**Attachment 18  
NRC3-10-0006**

**Response to RAI Letter No. 17  
(eRAI Tracking No. 4007)**

**RAI Question No. 02.05.01-30**

**RAI Question No. 02.05.02-02**

Figure 5 Bedrock Topography, Western Lake Erie

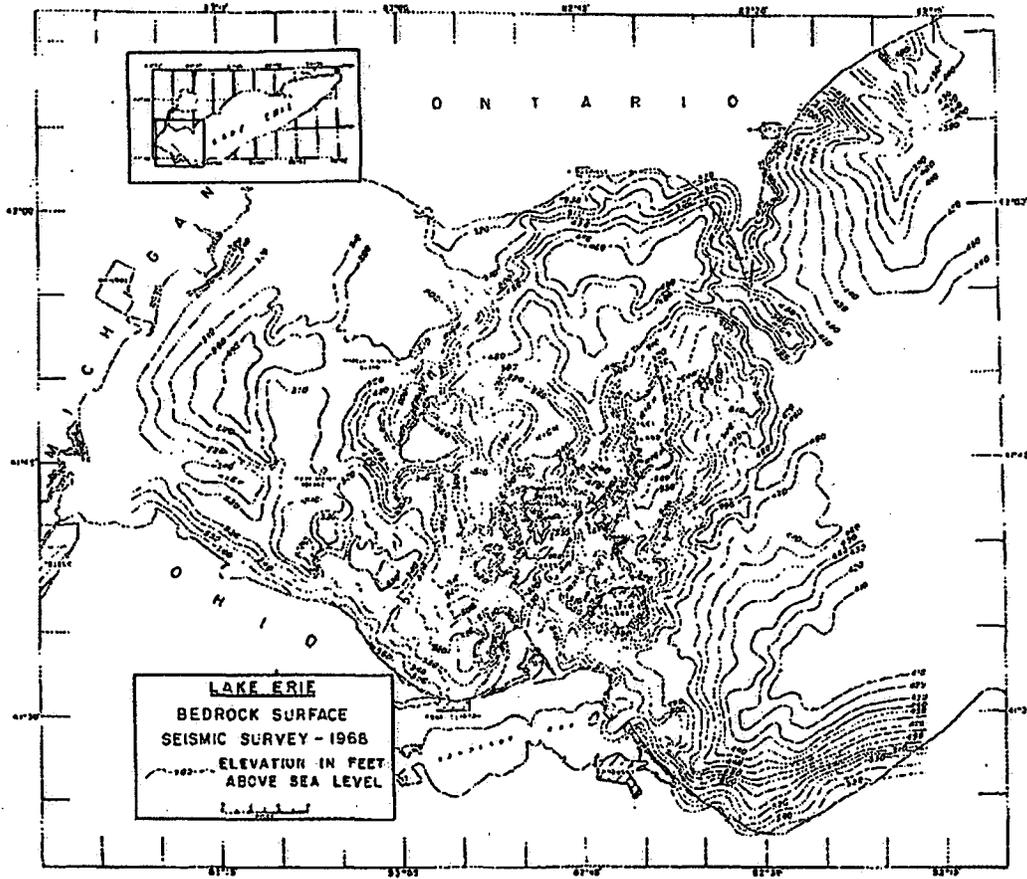
An eastward-flowing preglacial drainage system shown on Figure 6 was inferred from the thickness of unconsolidated sediment (Figure 4) and resulting bedrock topography map (Figure 5). This interpretation is based on assumptions that ice scour probably deepened the valleys preferentially and created closed depressions, without significantly altering the drainage divides, and that no significant differential earth movements have occurred since preglacial time. Hobson et al. (Reference 2.5.1-496) conclude that the drainage pattern appears to be a subsequent stream system that developed by headward erosion along the strike of weak bedrock zones of arched, northward-plunging Paleozoic strata in the Findley arch.

Figure 1 Colored Contour Interval Map (2-m Intervals) Showing Locations of Previously Mapped Paleo-shorelines

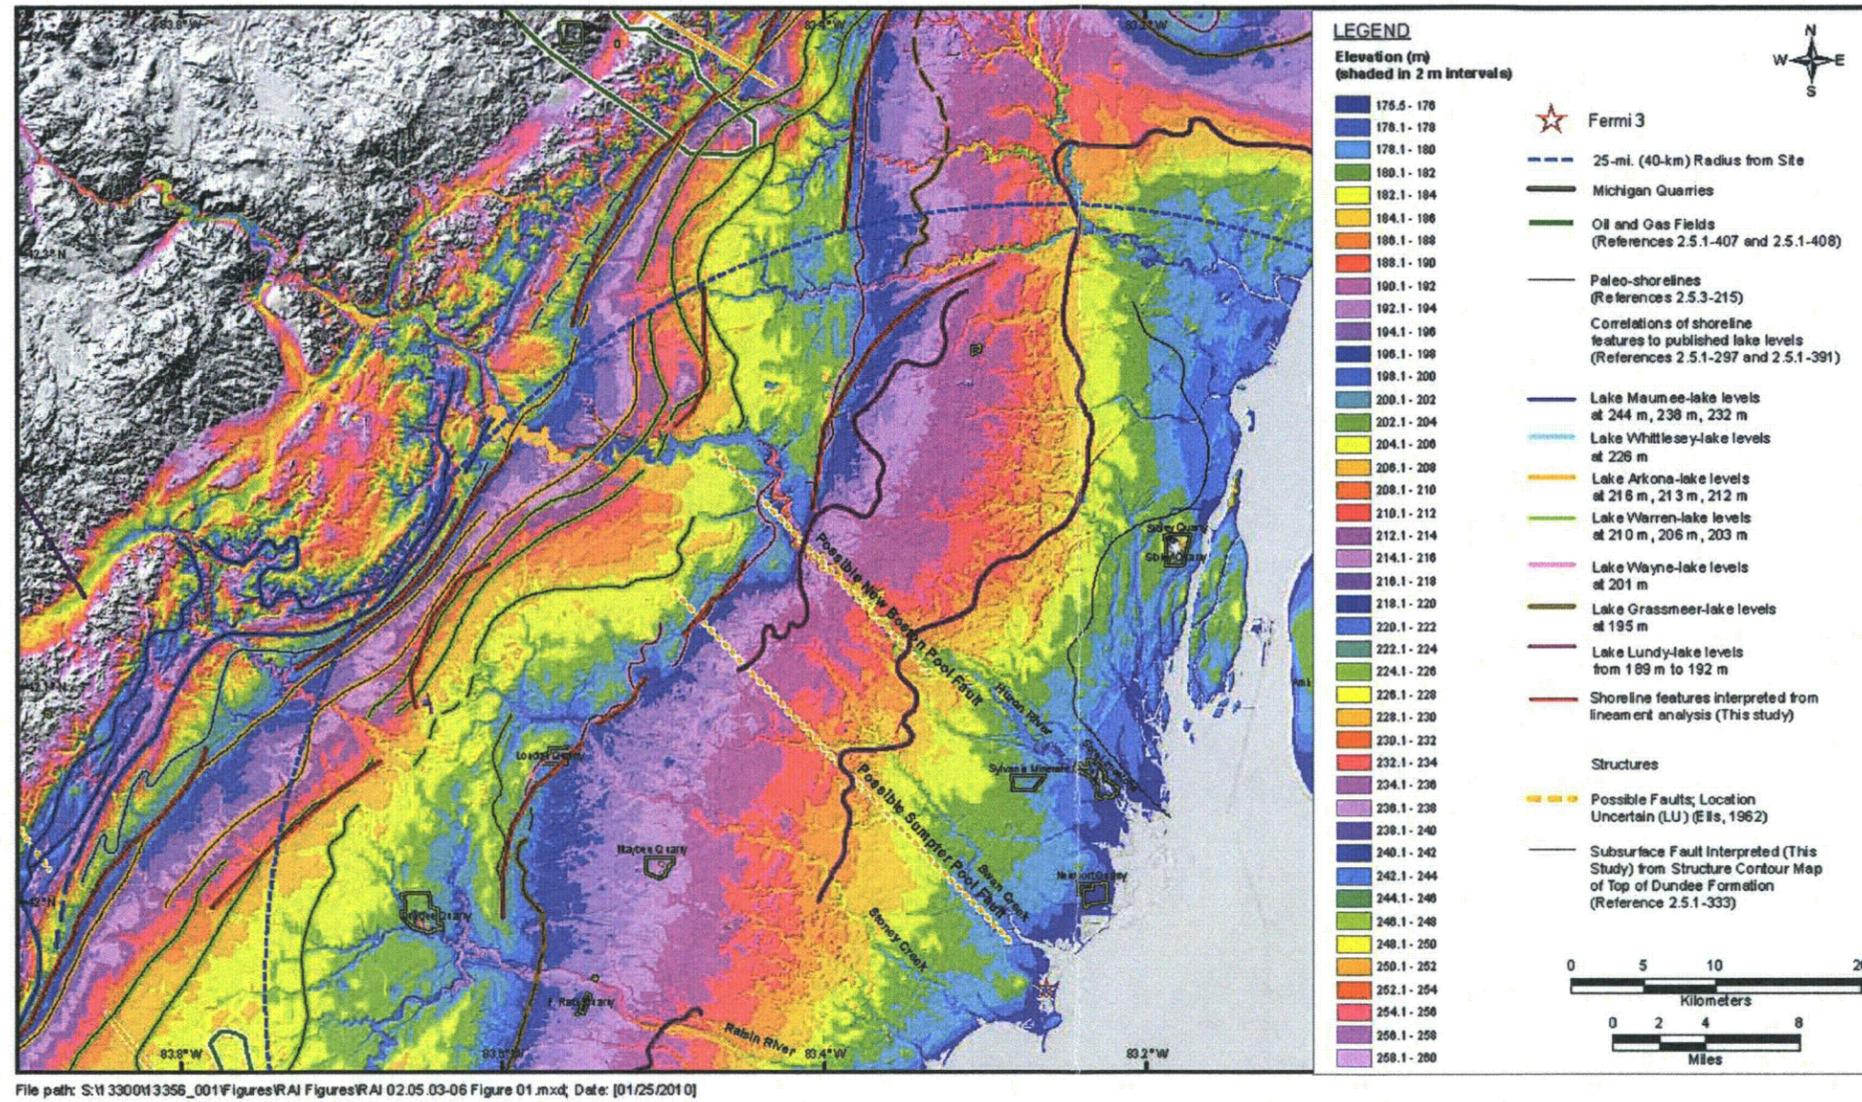
*FSAR Section 2.5.3.2.3 refers to FSAR Figure 2.5.3–201 and states that paleo-shoreline features in the site vicinity cross possible fault trends with no apparent disruption. Please indicate the resolution of this observation and whether it was based on field or map analyses. The FSAR does not address whether shoreline-elevation data in the site vicinity record possible deformation over a broader area. Please provide a discussion of this topic and, if tilting is evident, whether it can be attributed solely to glacial isostatic adjustments or whether it may suggest diffuse tectonic deformation. If appropriate, please include a figure showing elevation changes along paleo-shorelines identified in FSAR Figure 2.5.3–201 (in particular, n1 and n3).*

of maps highlighting different contour interval ranges (2 m and 0.5 m) (Figures 1 and 2, and FSAR Figures 2.5.3-210 and 2.5.3-213), as well as a series of topographic profiles (Figure 3, FSAR Figures 2.5.3-211, 2.5.3-212, 2.5.3-214, 2.5.1-256, and 2.5.1-257) was developed from the DEM to evaluate the continuity and variability of paleo-shoreline features across the site vicinity and mapped locations of the Sumpter Pool and New Boston Pool possible faults.

Figure 2.5.3-213 Colored Contour Interval (0.5-m Increments) Map Highlighting Surfaces Associated with the Lake Grassmere Lake Level (Elevation 195 m)

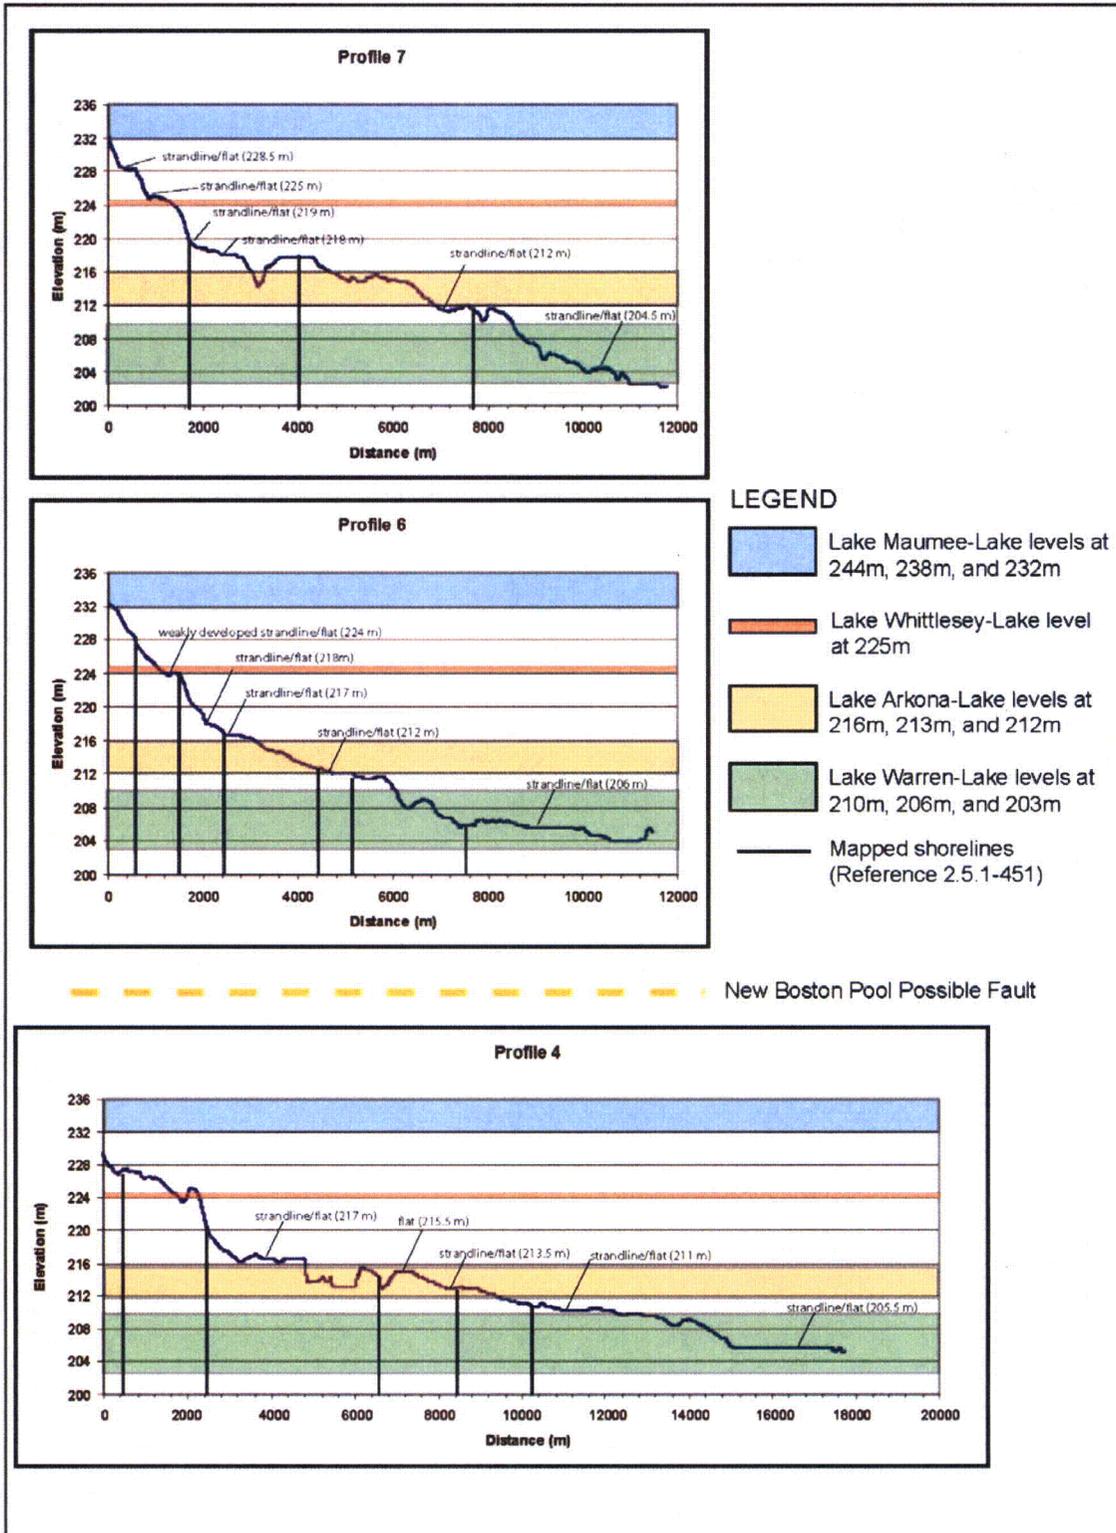
Evidence for the absence of tilting and/or localized differential vertical movement across possible faults mapped in the site vicinity also is illustrated by FSAR Figures 2.5.3-213 and 2.5.3-214. The locations of topographic profiles on opposite sides of the Sumpter Pool and New Boston Pool possible faults are shown on FSAR Figure 2.5.3-213, with the topographic profiles shown on FSAR Figure 2.5.3-214. The topographic profiles in FSAR Figure 2.5.3-214 show three surfaces associated with the Grassmere Lake level (approximately 195 m). The elevations of the three surfaces are indicated on FSAR Figure 2.5.3-213 in pink for elevations 193.6 – 194 m in white for elevations 194.6 – 194 m, and in black for elevations 196.1 – 196.5 m, with these surfaces separated by slight risers (blue intervals). The brown band in FSAR Figure 2.5.3-214 corresponds to the range in estimated elevations from 193.6 to 196.5 m for the Grassmere Lake levels. The three surfaces identified on the topographic profiles; all lie within the brown band representing the estimated elevation range of Grassmere Lake (FSAR Figure 2.5.3-214).
